## **Additional Questions:**

**292-6028**

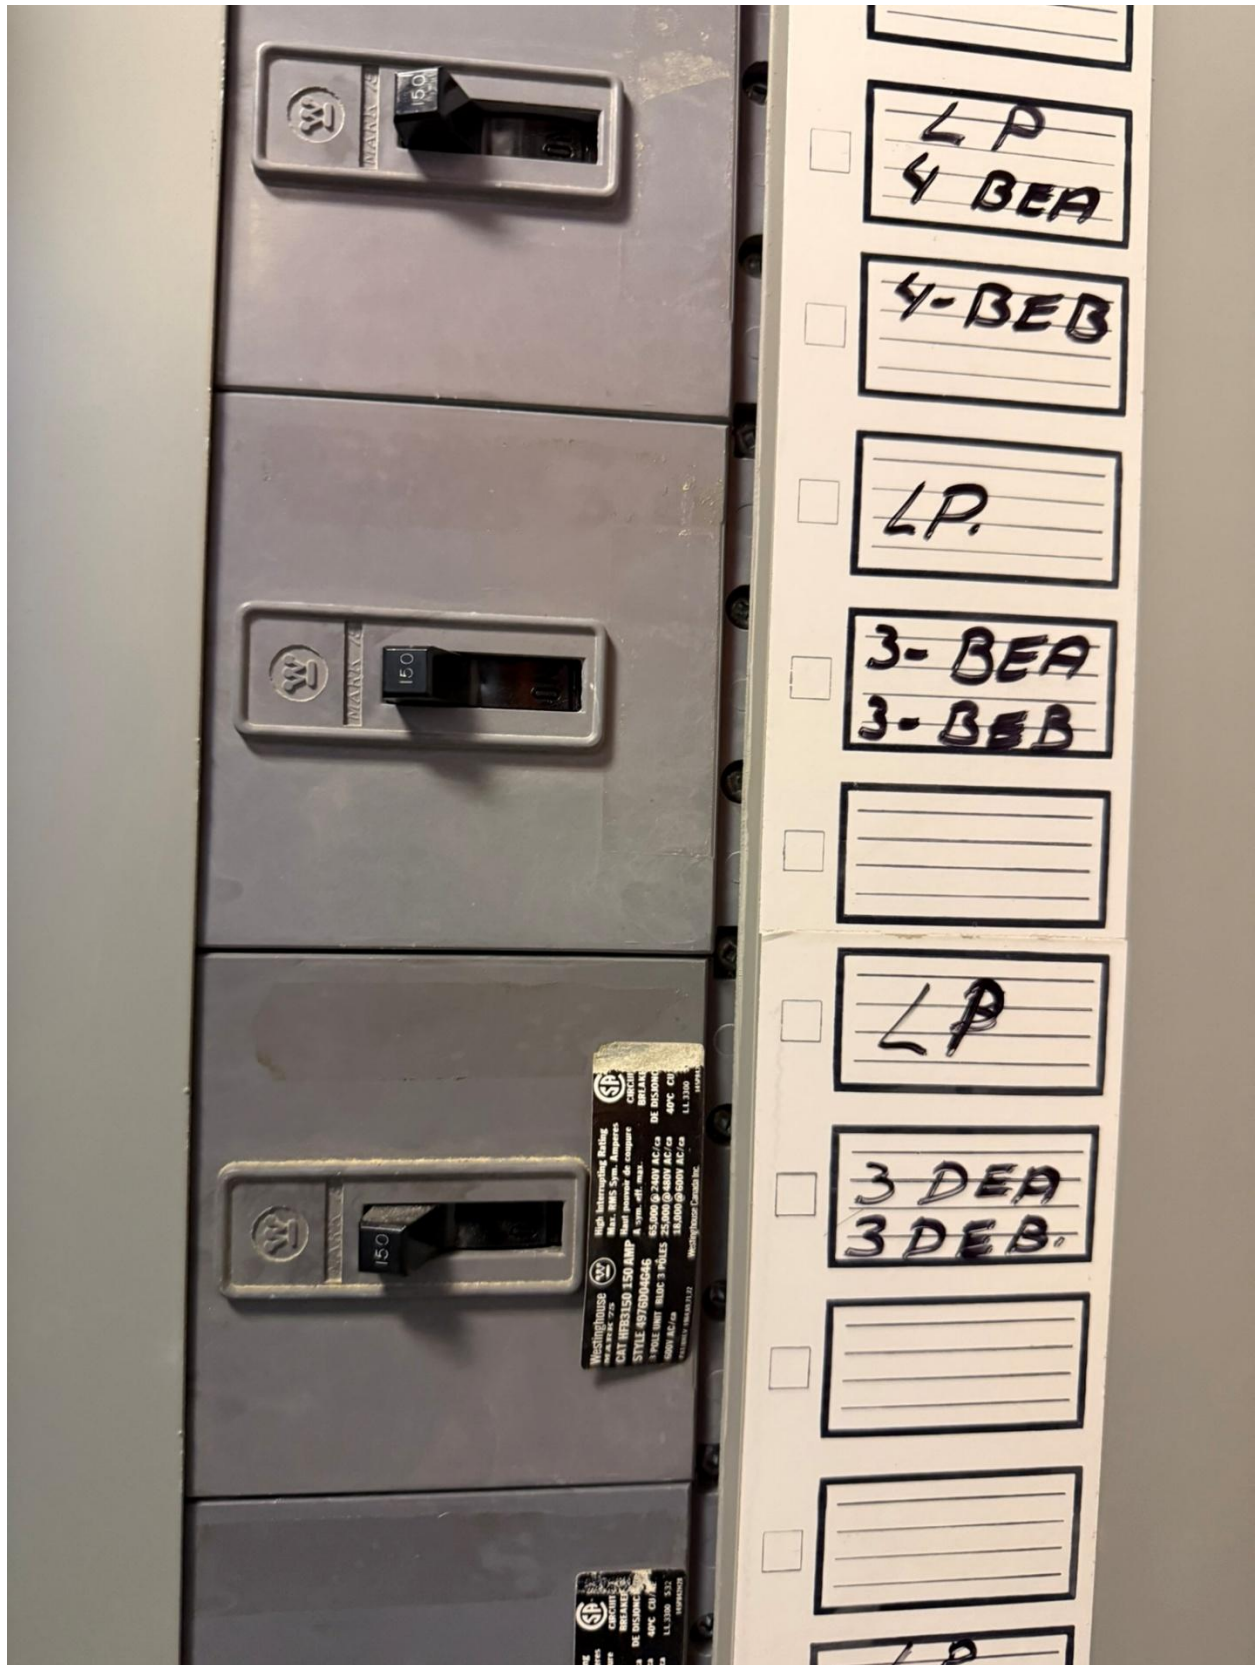
**Question 5: As per electrical addendum E-01, we have to provide 4 new 150A breakers in existing panels PP-SD-B-EAA & PP-SD-B-AA. Here, we need photos of these panels with breakers details and panel details such as manufacturer, panel amperage, voltage and KA Rating.**

Photos below
